Errata to ICC/ANSI A117.1-1998, First Printing

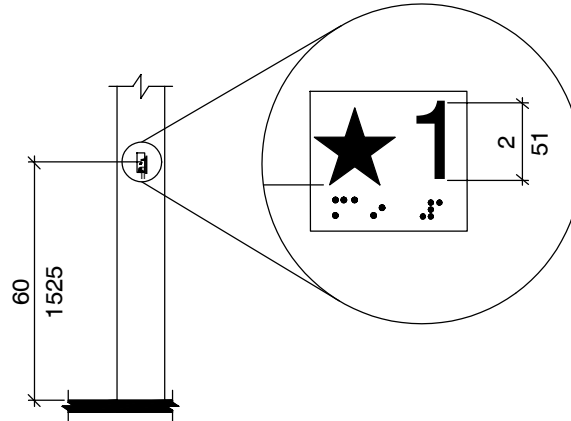
1. Page 15, Table 404.2.4.1: In footnote 2, change the metric equivalent to 305 mm
2. Page 17, Section 404.2.4.4: Typo in title (Recessed)
3. Page 23: Revise Figure 407.2.4 as follows:

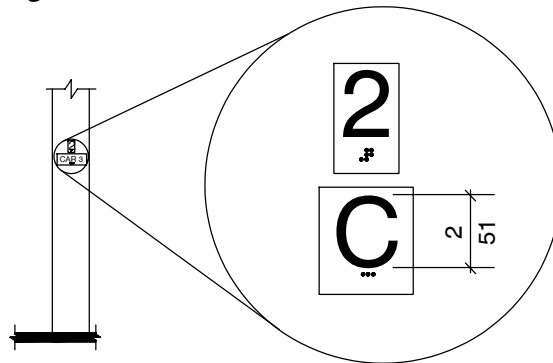
4. Page 27: Revise cross reference in Section 407.3: "...shall also comply with 407.3.1 through ~~407.3.5~~ 407.3.6 and..."
5. Page 28: Revise Figure 407.3.5 as follows:
